THE CITY OF SAN DIEGO

M E M O R A N D U M

SUBJECT: November 17, 2022 Planning Commission Hearing, Item 1: 1542 Copa De Oro SCR – Project No. 699239

Figure 1 - PTS Layers

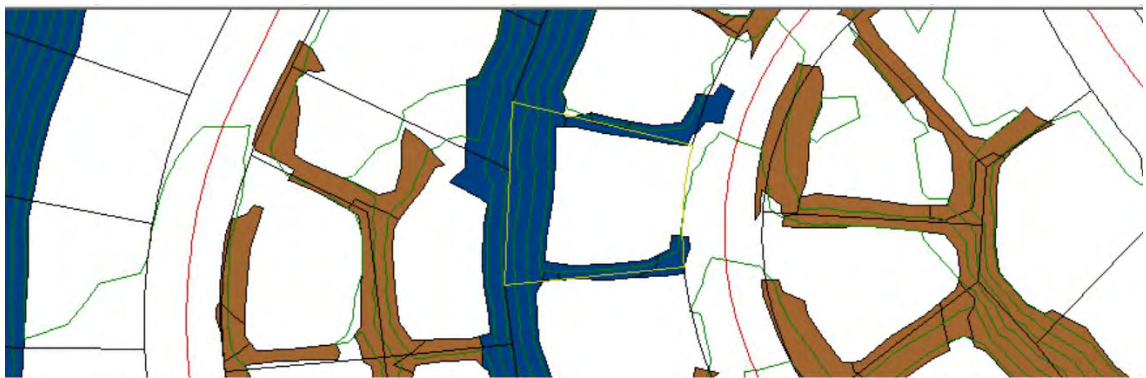
The Project Tracking System (PTS) layer shows steep hillsides in navy blue on the rear of the lot; however, the height differential of the lot is 20' feet from contours 395' feet to 415' feet from sea level within a previously developed lot. The steep hillsides area identified in navy blue is also not within a system of canyons and is located in between two existing streets, Copa de Oro Drive and Vista Claridad.

The site does not contain ESL, this has been previously established during reviews by City Staff for Project 664766 which was a ministerial building permit review for an addition and remodel of the existing home; during an on-site visit on August 4, 2020; and through City Staff review of Project No. 676181 which is the previously approved Coastal Development Permit (CDP) associated with this SCR. Project No. 676181 – Copa De Oro CDP, LDR-Planning clearly states in review comment 23, the following:

Additionally, per building permits issued in 1971, the site was previously graded for the existing development. Therefore, no natural slopes are located onsite for the consideration of steep hillside ESL.

Figure 3 City of San Diego Zoning and Parcel Information (ZAPP)

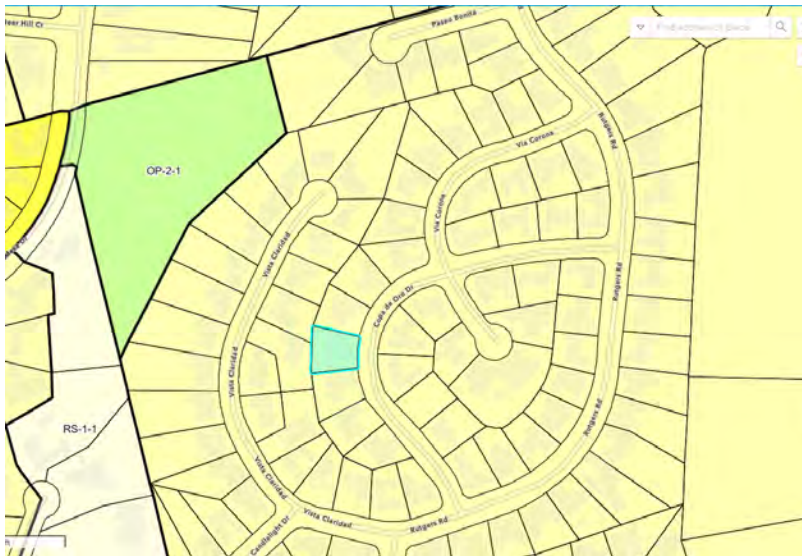
Ms. Baker's identification of steep hillsides during SCR, and the City's failure to require a site-specific study to determine if there are steep hillsides is new information. The City also failed to consider if open space exists on the Property. The Planning Commission, in weighing this evidence, should consider how this new information affects the CDP and SCR approvals. For instance, if steep hillsides exist, a Neighborhood Development Permit ("NDP") is needed in addition to the CDP. SDMC Table 143-01A(1) *Steep Hillsides*. If a deviation is sought to allow the encroachment, a Process Four Site Development Permit ("SDP") is also required. SDMC Table 143-01A(6) *Steep Hillsides*. The fact that only a CDP Process Two was used when a NDP and SDP Process Four should have been required should weigh heavily as new information for the Planning Commission's consideration.

The site does not have an open-space easement on it. The only open-space easement is to the Northwest listed as OP-2-1 as shown on the map from the City Zoning and Parcel Information (ZAPP, figure 3) portal. No Open Space Exist on this project Site. This site was already developed and the City's environmental determination is "Categorically exempt from CEQA pursuant to CEQA State Guidelines, Section 15301, Existing facilities". Therefore, the City's decision that the site is exempt was correct as the site was already developed and there is no existing open space on the site.

Cantilevered Deck Encroachment Image and Site Plan

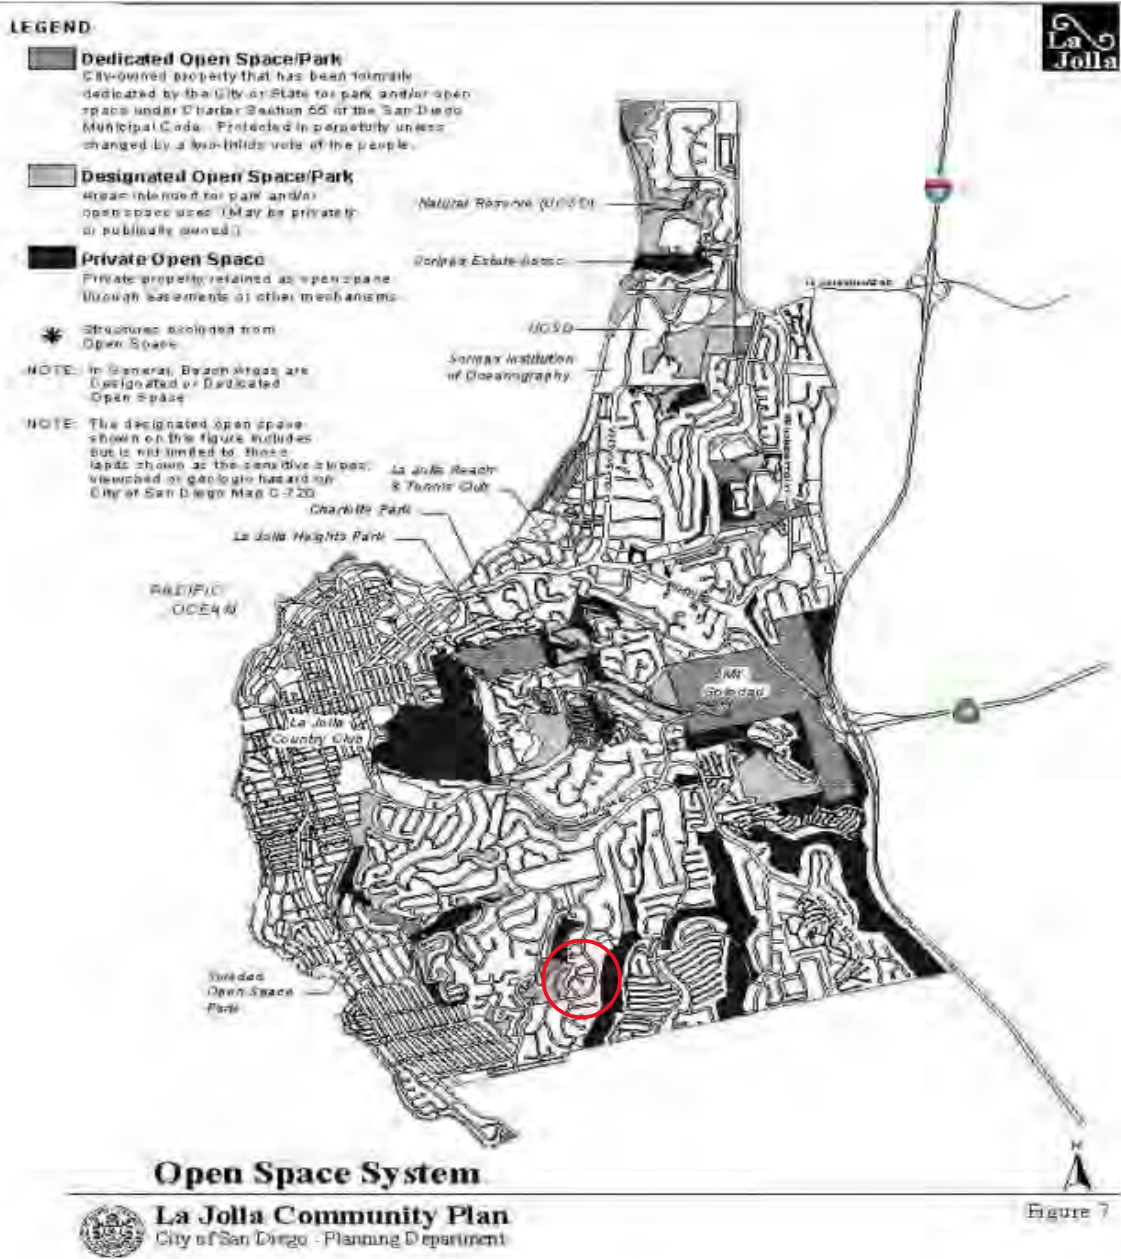
At that point, the City should have required applicant to perform a site-specific study to determine whether ESL and open space existed on the Property. Ms. Baker did request the pool be removed out of the ESL. However, she did not require that the large 288 square foot concrete deck that is encroaching into the steep hillside south of the pool be similarly removed out of the ESL ("Deck"). See Exhibit B. The Deck appears to be encroaching substantially more than the pool was encroaching in the ESL, perhaps at least five feet. See Exhibit A.

Furthermore, should applicant request a deviation to allow the Deck encroachment, the City's Steep Hillside Guidelines specifically preclude allowing decks to encroach into steep hillsides at all.

Private Residence
COASTAL DEVELOPMENT DOCUMENTS PACKAGE - SCR
1542 Copa de Oro Dr, La Jolla, California, 92037

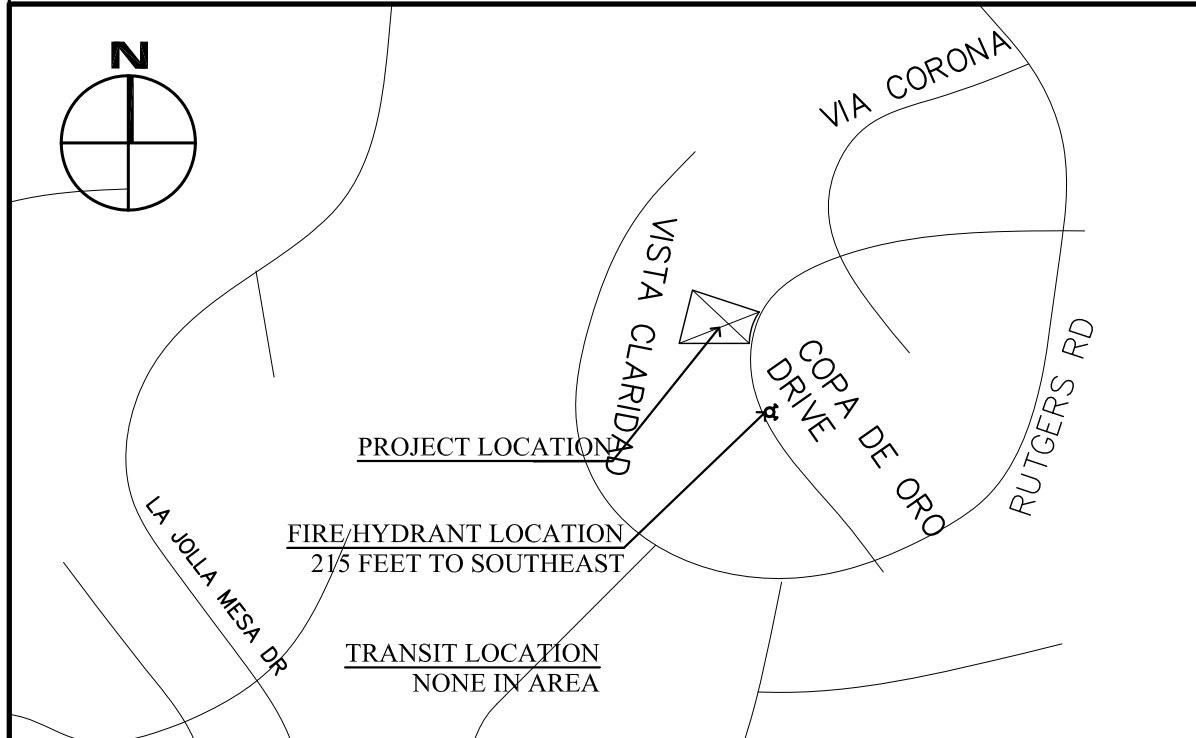
It should be noted that while the City's SCR approval lists 3,936 sq. ft. as the new total building area, there are substantial discrepancies within the applicant's plans regarding the total square footage. The original written scope of work for CDP No. 2482866 states:

The SCR requested and was granted an increase over the original CDP of 281 sq. ft., from 3,655 sq. ft. to 3,936 sq. ft. The written scope of work states that the net addition to existing first floor habitable area is 1,041.07 sq. ft. Again, on a basic level, 755.65 (original CDP expansion) + 281 (additional SCR expansion) =

1,036.65, not 1,041.07 (new total expansion). Also, 2,871 (original building area) + 1,041.07 (SCR addition) = 3,912.07, not 3,936 (SCR building area). Furthermore, the applicant’s provided building area calculation states that the existing building area was 2,873.7 sq. ft. with an addition of 1,277.06 sq. ft., for a total of 4,150.8 sq. ft. On a fundamental level, the written scope of work and building area calculations for the SCR do not agree with each other, nor do they provide an accurate description of the actual work proposed.

Revise the previous approved Coastal Development Permit Number 2482866, Project No 676818, with approved total of 3,655 square feet. This Substantial Conformance Review of the CDP is requesting an increase of 287 Square Feet for a new total of 3,942 square feet. The revised home will add 271.2 square feet of habitable square footage + 15.6 square feet of garage area to total addition of 287 Square Feet or 7.9% increase from the approved CDP.
